CODE ANALYSIS

PROPERTY ADDRESS: EDWARD JONES - BRANCH OFFICE: 01643
500 SW MARKET STREET, SUITE C
LEE'S SUMMIT, MO 64063-3987

Edward Jones
BRANCH REAL ESTATE

RELEASED FOR
CONSTRUCTION
As Noted on Plans Review

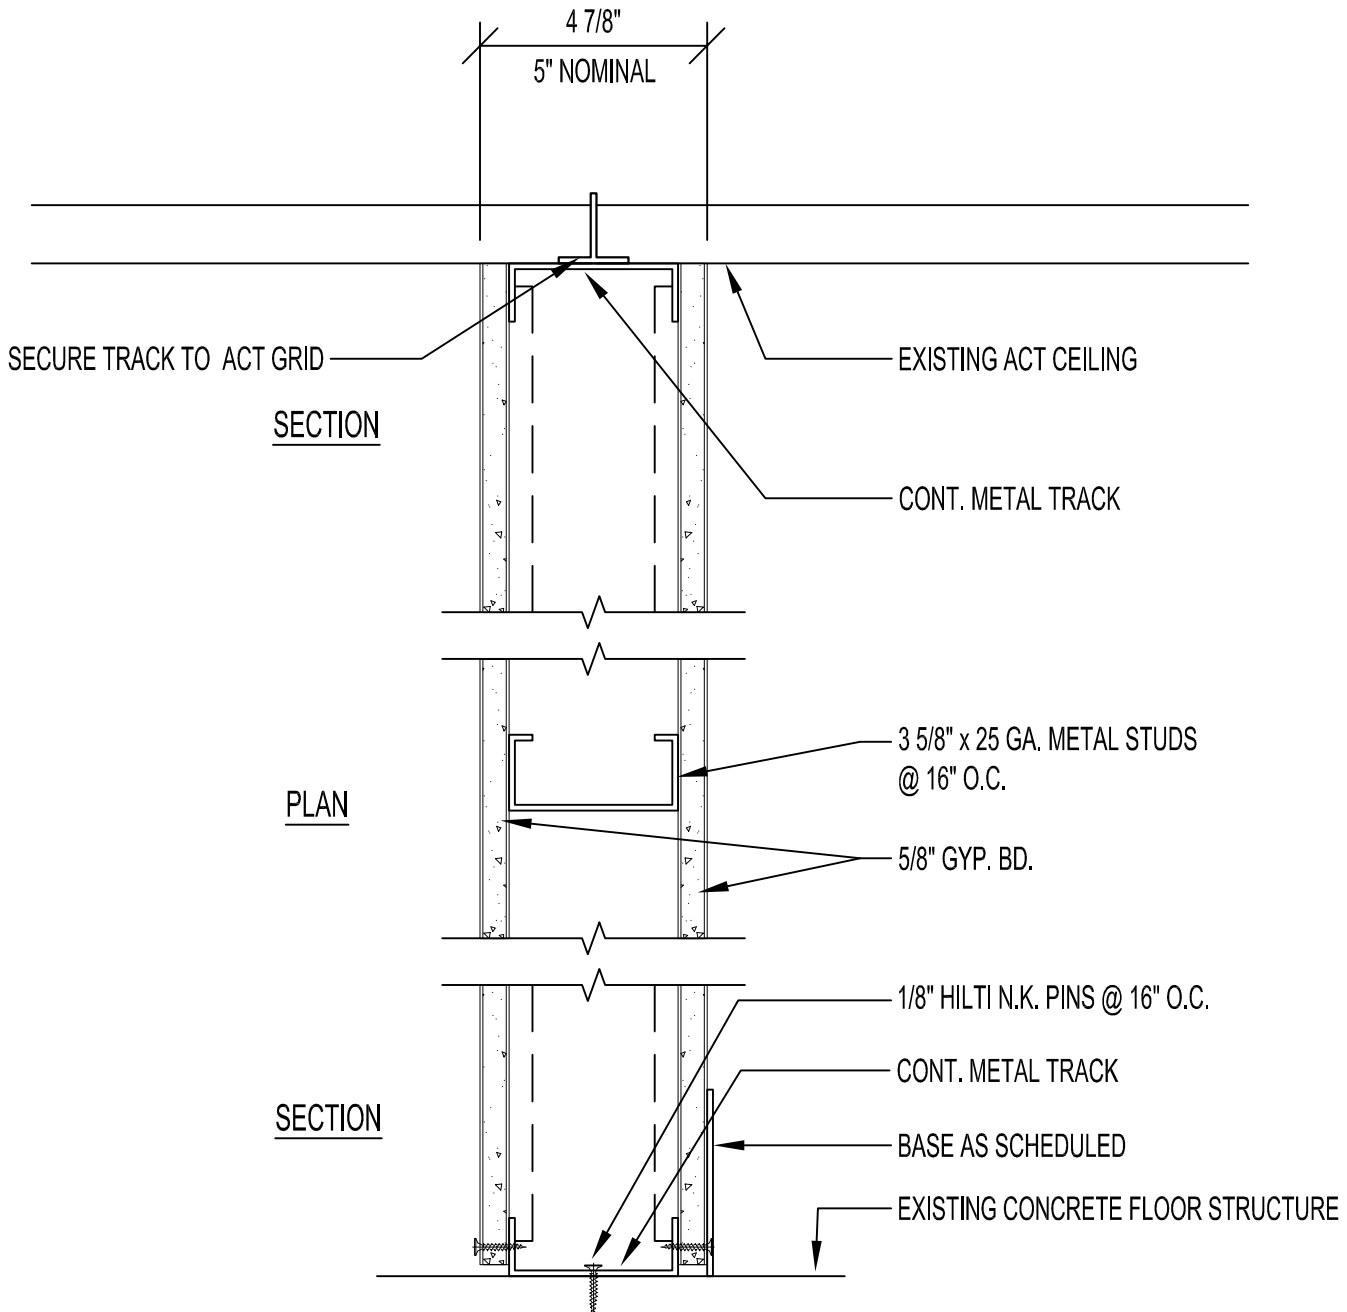
CONSTRUCTION TYPE: ~~2B~~ 3B
